To: Oshawa Active Transportation Advisory Committee OATAC

From: OATAC Projects Working Group 2023-02-01

Subject: Design of Roundabouts

Figure 6.81 – Single-Lane Roundabout, PXO Crossing Treatment

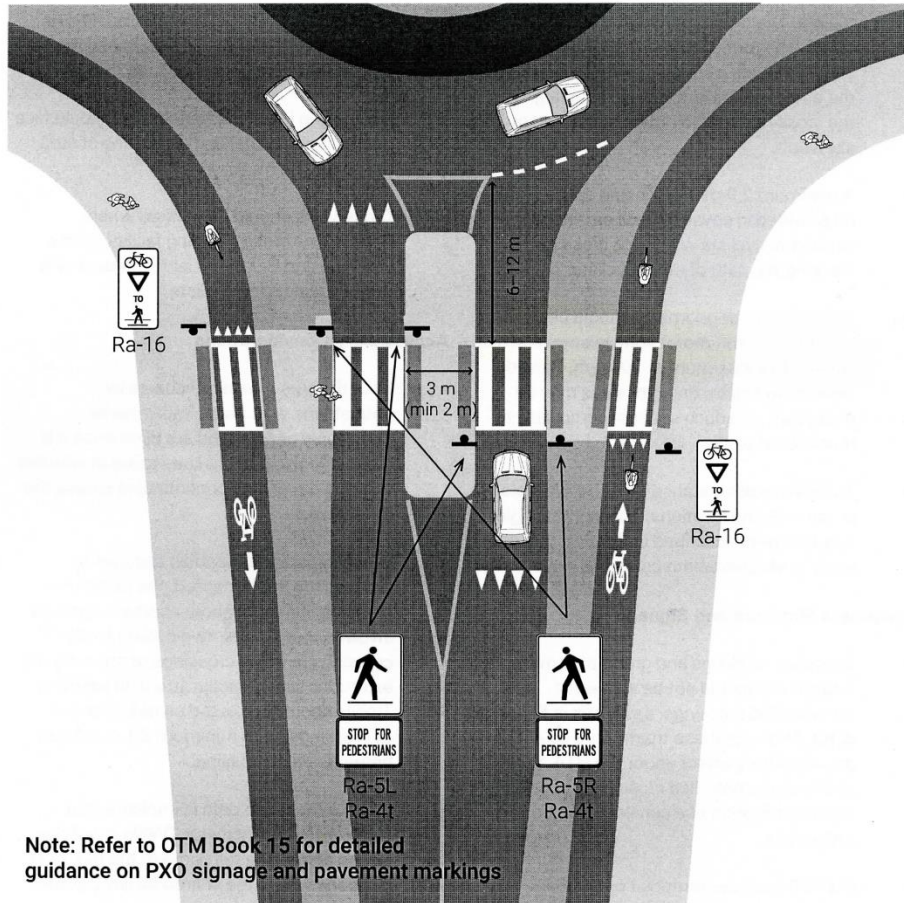
- 3.5 As illustrated in figure 6.81 for single lane roundabouts, markings are painted on the road and signs are installed that instruct motorists to stop for pedestrians. Pedestrians have the right-of-way. At these crossings

cyclists are to walk their bicycle across the road and are considered pedestrians.

- 3.6 These are not mid-block crossings. These are intersection crossings that provide for the continuous movement of pedestrians and cyclists along their sidewalk or multi-use path. The safest designs should be made to encourage multi-modal travel and reduce accidents, particularly to the most vulnerable. It is O.A.T.A.C. opinion that the uncontrolled crossing design is a leftover from the auto's at any cost days.

The current thinking is to install figure 6.81 design where auto volumes are low. If auto volumes are low, the requirement for traffic to stop for pedestrians crossing the street at the intersection would not be onerous for auto drivers and would be safer and convenient for pedestrians, particularly the most vulnerable. The City should have a policy that the safer design, figure 6.81 be the only design at single lane roundabouts in the City.
